| TYPE | YEAR | PROJECT NO. | SHEET NO. |
|---|---|---|---|
| R.O.W. | 2015 | HSIP-106(33) | 30 |
| CONST. | 2017 | HSIP-106(33) | 40 |

CRITZ LANE WILLIAMSON CO.

BEGIN STA. 18+50.00
END STA. 19+00.00

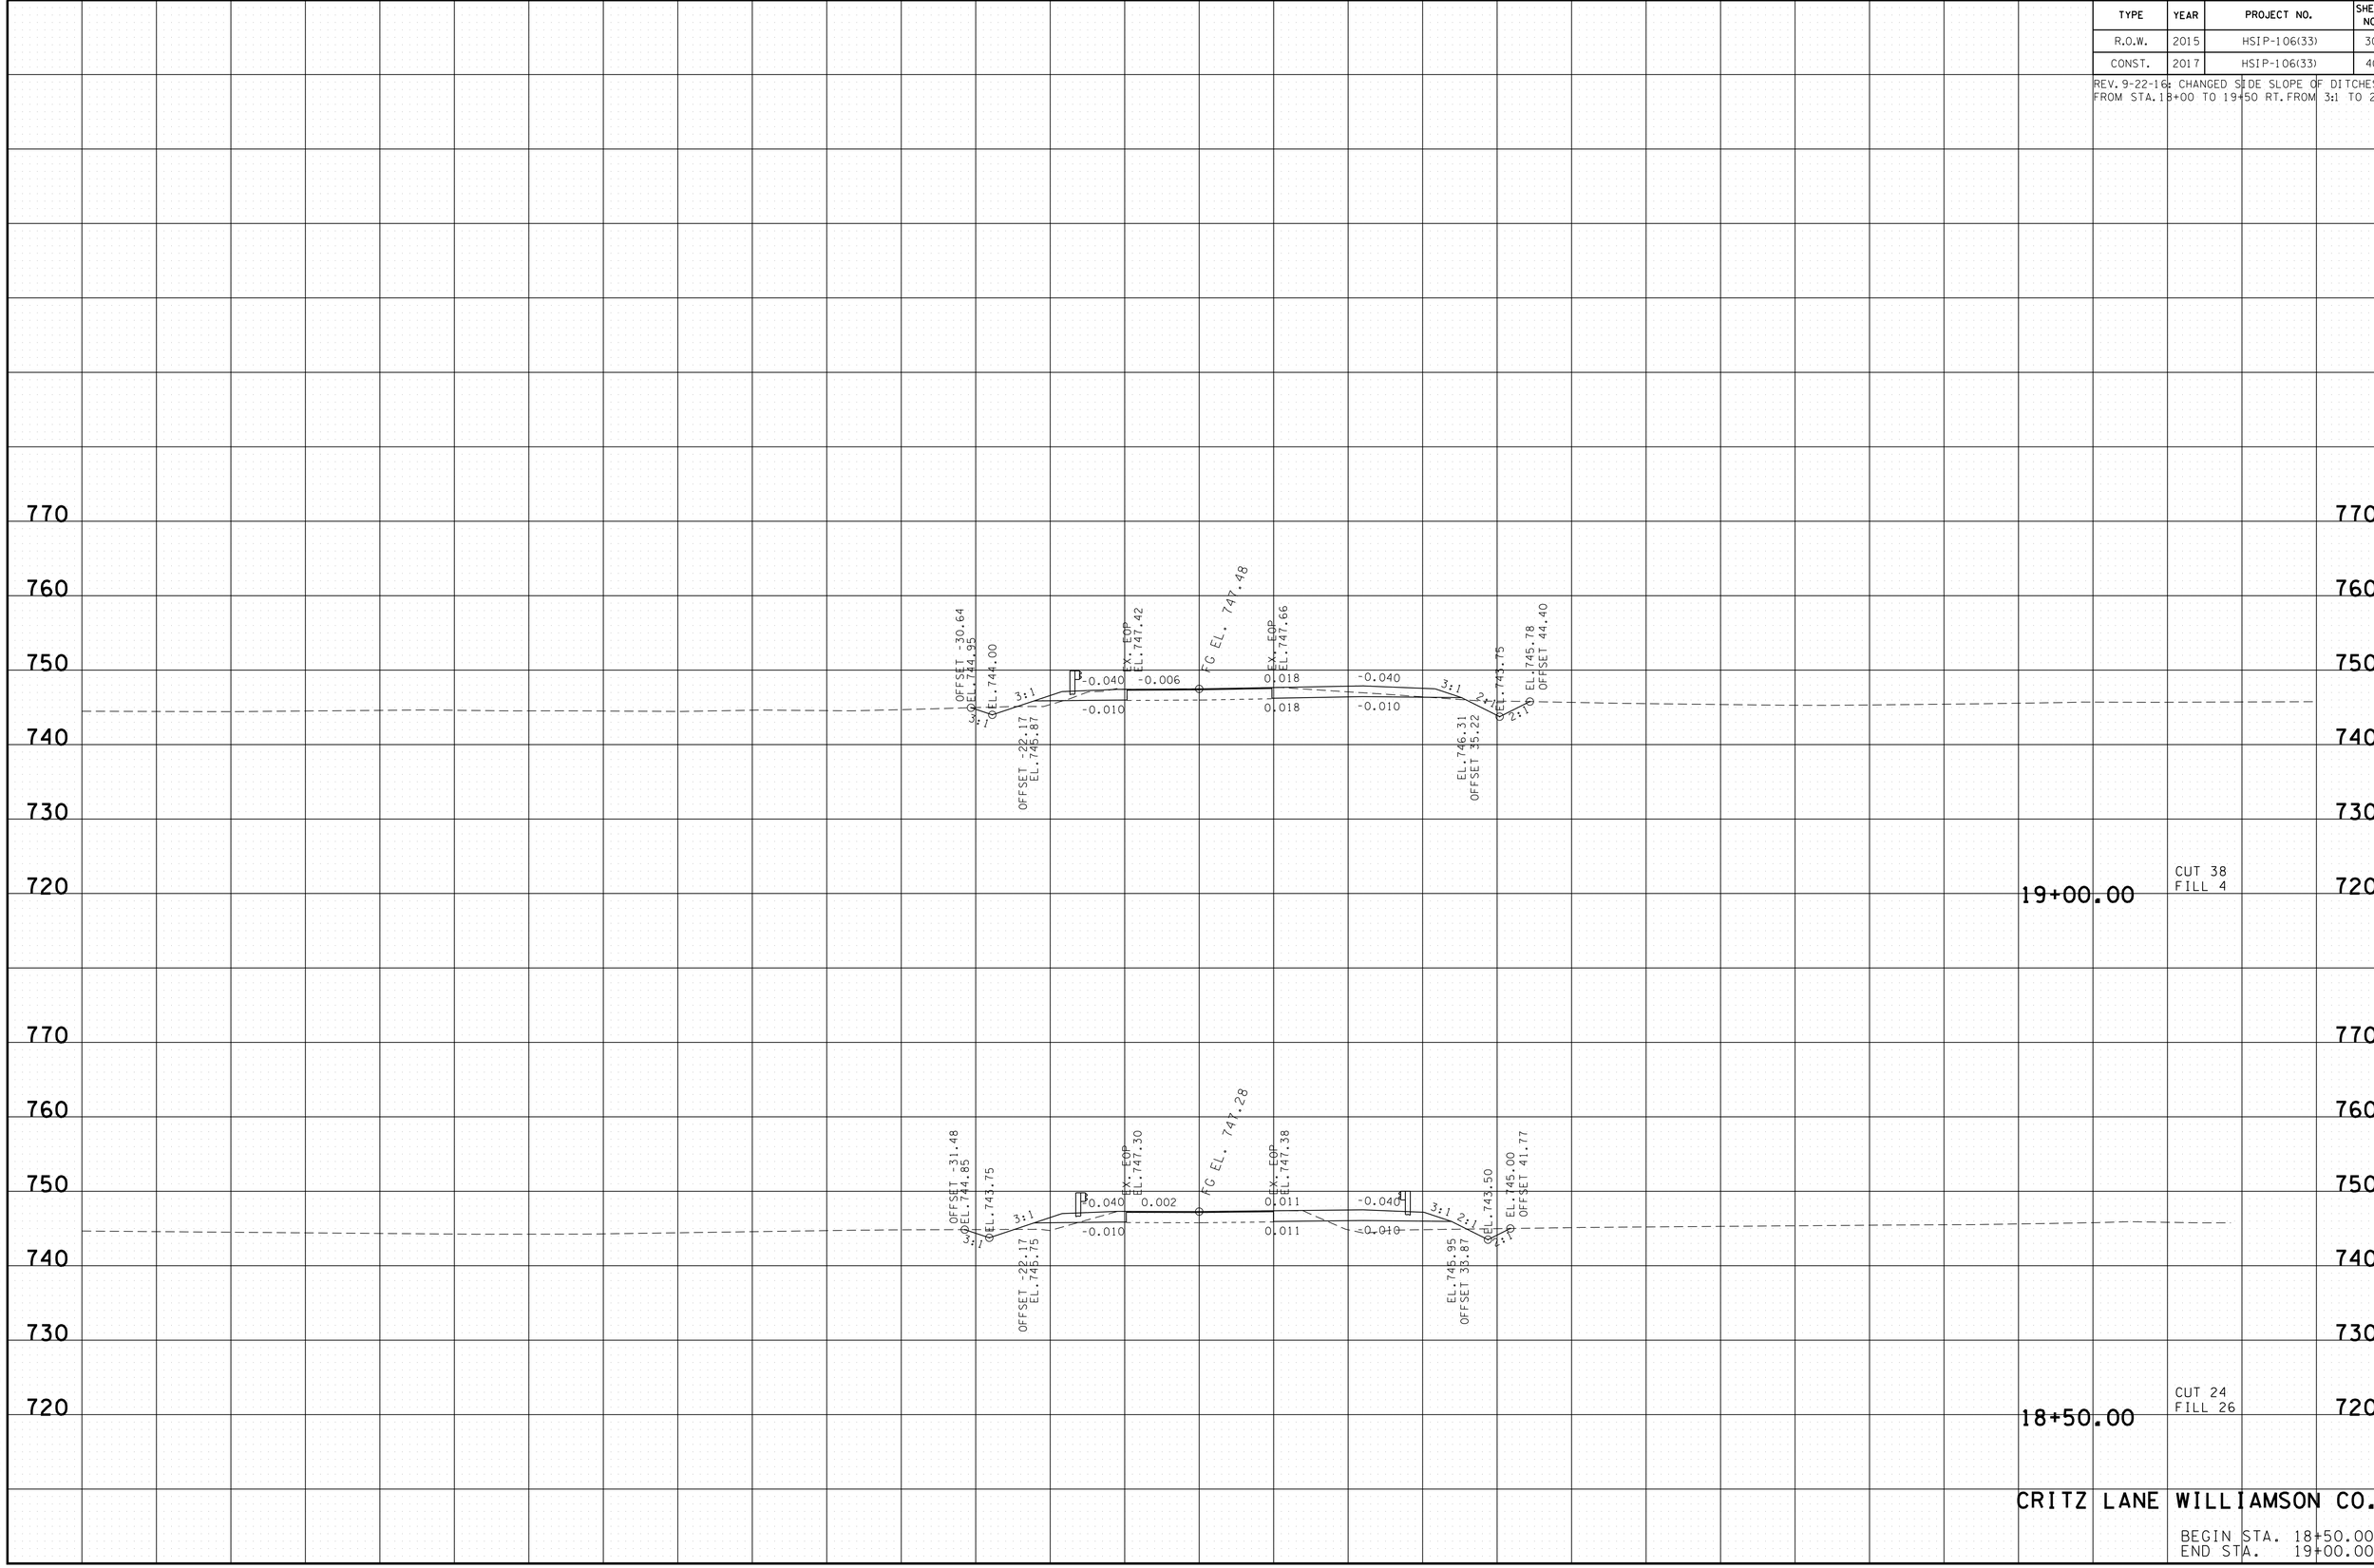
REV. 9-22-16: CHANGED SIDE SLOPE OF DITCHES FROM STA. 18+00 TO 19+50 RT. FROM 3:1 TO 2:1.
